BROOKHAVEN NATIONAL LABORATORY
ASSOCIATED UNIVERSITIES, INC.

Subject: Fire Protection in Turkey Point Nuclear Power Plant - Units 3 & 4,
Request for Additional Information

ATTACHMENT 1

STRATEGY #17

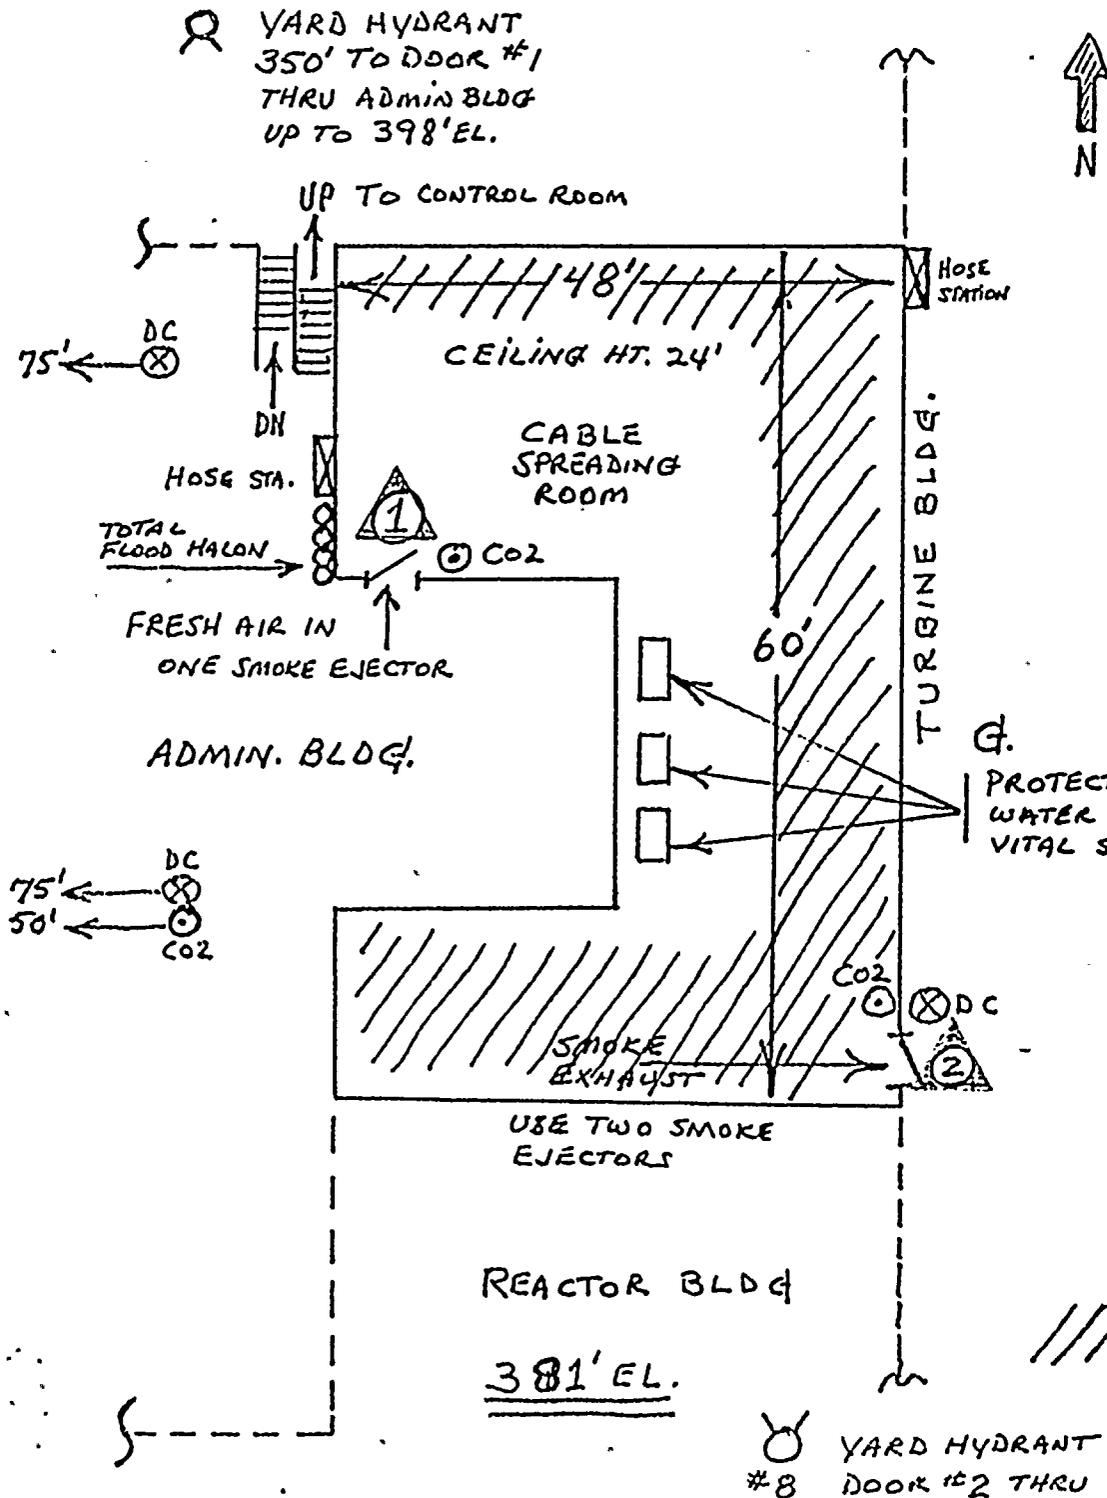
An examination of specific locations at Turkey Point showed that there were areas where the BNL consultant determined that three fans were required due to the large size of these areas. An example of this is the 4160 volt switchgear rooms which contain approximately 14,000cu. feet each, and the long hall in the auxiliary building which contains approximately 21,000cu. feet. These areas and other large areas may require one fan blowing fresh air in and two fans exhausting smoke.

A typical large room pre-fire plan is attached showing the recommended fan arrangement, Ref. Figure 1.
